Development Control Unit

HUNTER'S HILL COUNCIL
DEVELOPMENT CONTROL UNIT
7 May 2024

- 2.1 11 William Street, Henley 1

Figure 1 shows the long wall facing 18 Crown Street along the western elevation.

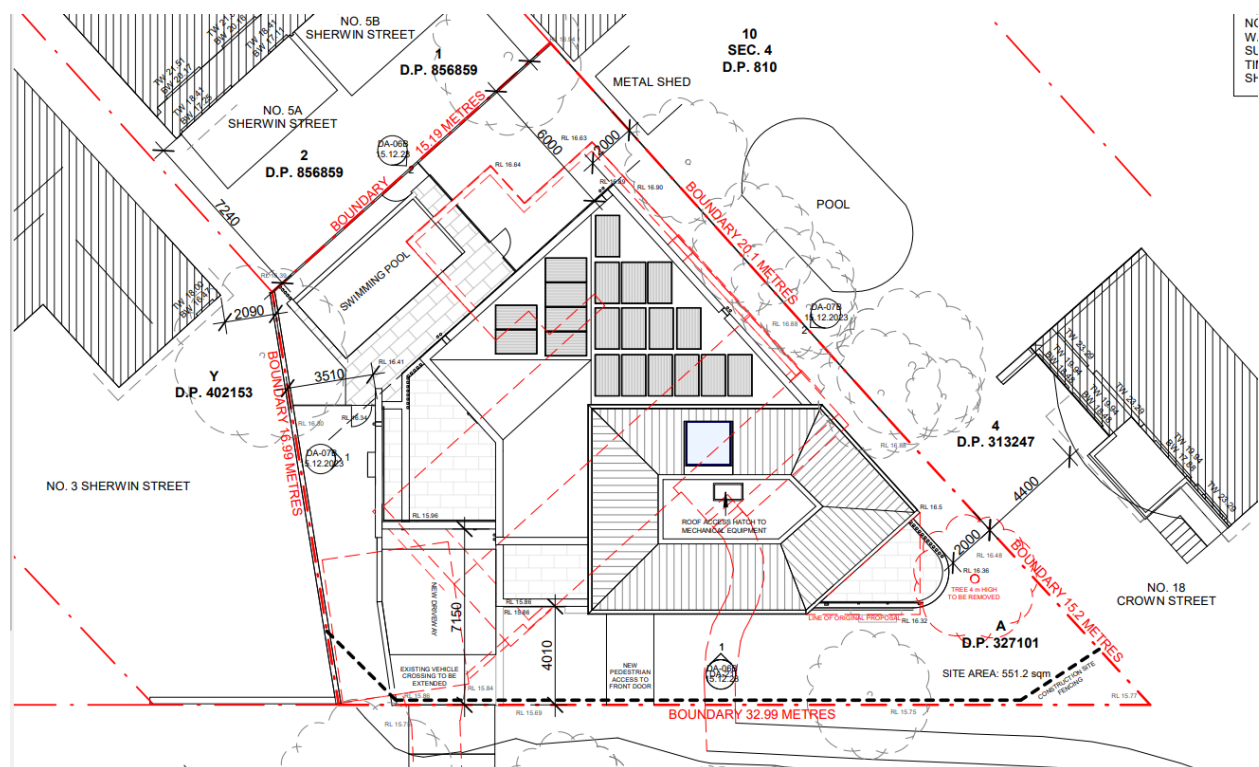
The wall length however, on the western elevation is not acceptable and presents a blank elevation towards the property to the west.

Figure 2: Site Plan showing the proposal relative to 3 Sherwin St and the proposed north-eastern balconies.

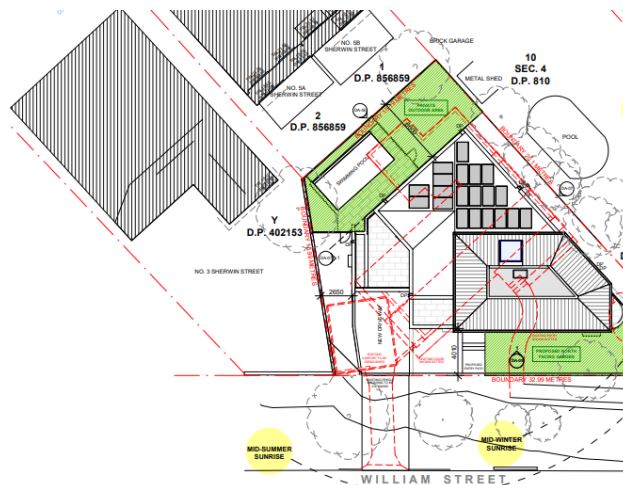
The proposed development includes first-floor balconies along the north-eastern elevation of the dwelling. Concerns are raised that these balconies will have full view of our client's property resulting in the loss of privacy to their private open space, due to the elevated nature of the balconies and their position relative to our client's property. As Council would be aware, 3 Sherwin Street has a current approval for a 2-storey dwelling house.

In order to maintain/protect the privacy of 3 Sherwin Street, it is requested that a solid vertical blade wall to a minimum 2m in height above the finished level of the balconies and extend 600mm past the edge of the balconies be erected along the south and eastern elevations of the balconies. The vertical blade walls, as marked in Figures 4 & 5 above, should be of a material and finish that complement the material and design of the proposed dwelling house. The pre-finished vertical batten type privacy screen shown on the architectural drawings are not considered sufficient in preventing direct overlooking of our client's property.

Impact 1 – Sightline from within shower of bathroom

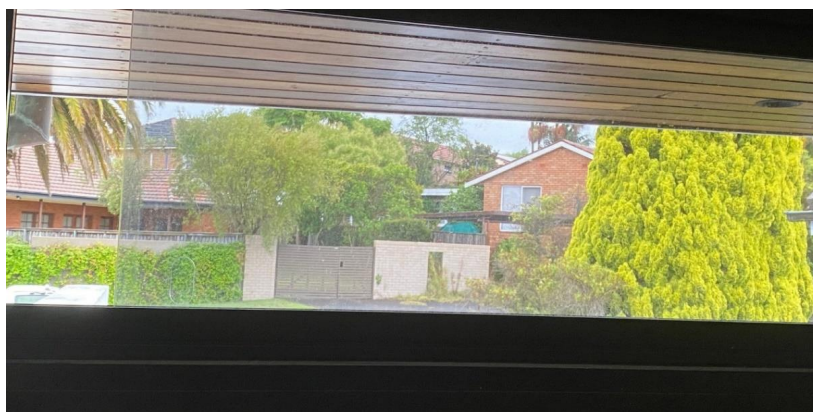
Sightlines can be further understood by considering relative levels and pictures taken from our impacted habitable rooms looking up to the proposed dwelling. Proposed plans suggest the RL of the development is suggested as 19900 - which is some 5 meters higher than our first floor at 14950. Therefore, persons looking out of the proposed dwelling on either the first or second floor decks or through windows towards our direction will overlook down and into these private areas of our

These pictures highlight the direct and invasive sightlines from the proposed development into our impacted private areas:
